November 2021
FL863A (Final)
INT FL863-01 (Interim)
NHTSA #20V-567
Transport Canada #2020-444
REVISED NOTICE

Subject: Freightliner Cascadia Brake Light Illumination

REVISION: Revisions were needed to add images of acceptable jumper harness variations, a brake light functionality test using DiagnosticLink, and to perform an air leak check.

Fig. 5, Approved Jumper Harness

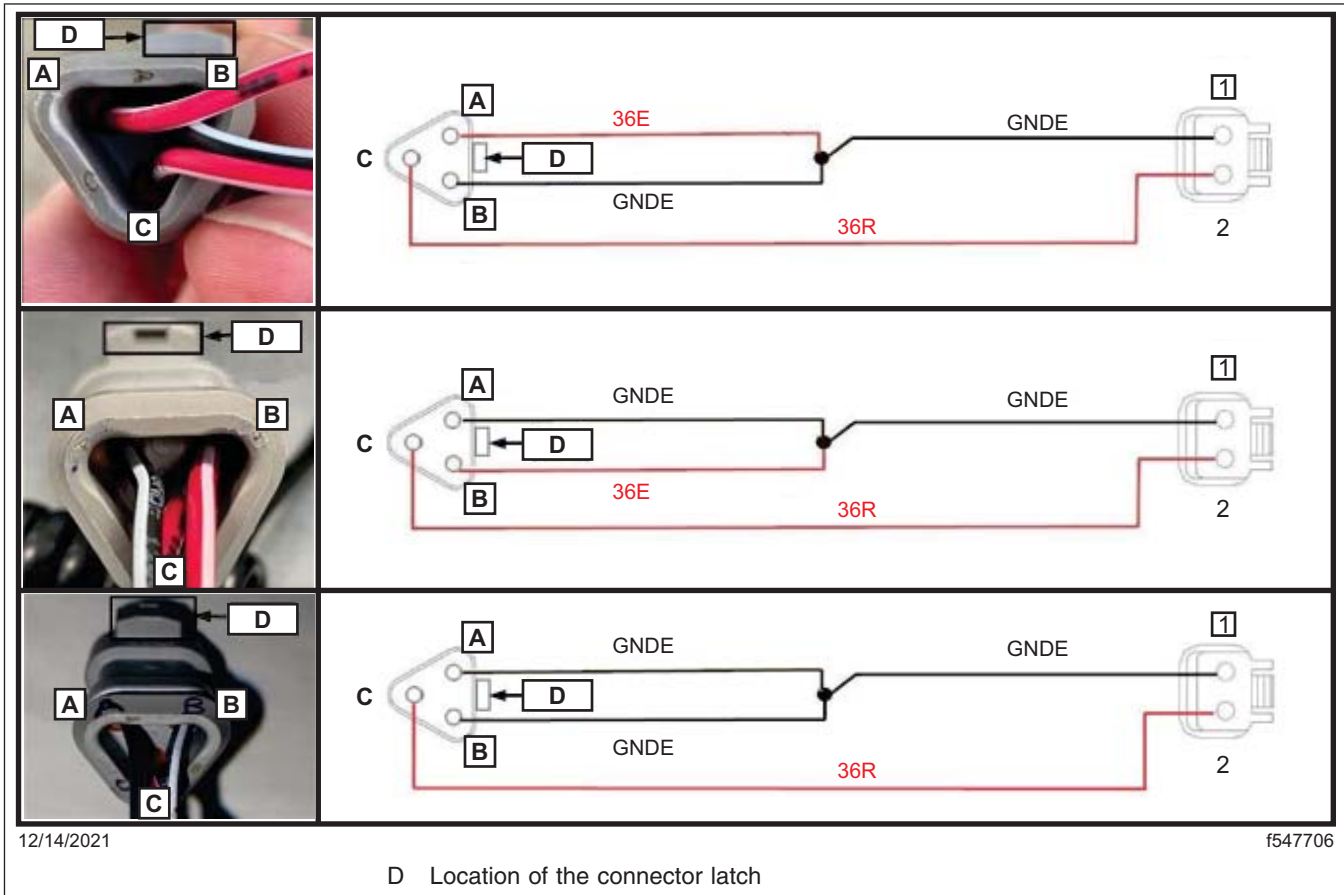
- 5.2 Install the jumper harness as shown in the **Fig. 3** onto the dash connector shown in the **Fig. 4** and then connect it to the new 2-pin brake light pressure switch. Due to jumper harness variation, see **Fig. 5** for details of approved jumper harness variations. Vehicles in FL863A go to sub-step 5.4.

- 5.5 With a minimum vehicle system air pressure of 60 psi, check the vehicle brake light function with DiagnosticLink while pressing & releasing the vehicle brake foot pedal and if equipped, pulling the vehicle trailer hand brake valve. The "Service Brake" panel status should show both "OFF" in normal state when brakes are not applied, see **Fig. 7** and show as "ON" when the brake foot pedal is pressed or if equipped, when the trailer hand valve is pulled. See **Fig. 6**. A slight delay between status of "OFF" and "ON" is normal. If the brake light function is not correct, check that jumper harness matches the acceptable variations on **Fig. 5** and is fully connected to dash harness and to brake pressure switch.

Fig. 7, Service and Park Brake Panel Status in Normal State

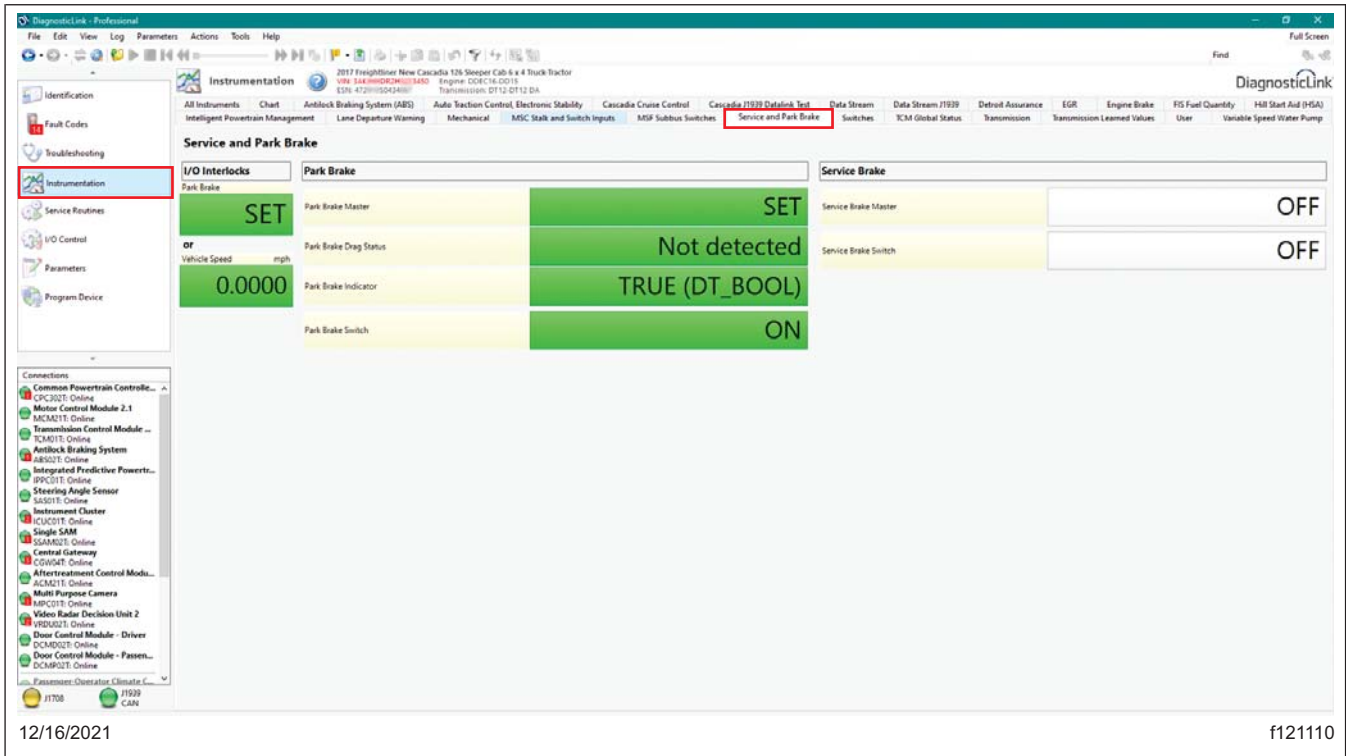
- 5.4 Open the DiagnosticLink and connect to the vehicle, turn vehicle ignition switch on, allow time for DiagnosticLink to connect with sSAM, open the "Instrumentation" tab, locate and open the "Service and Park Brake" panel. See **Fig. 7**.
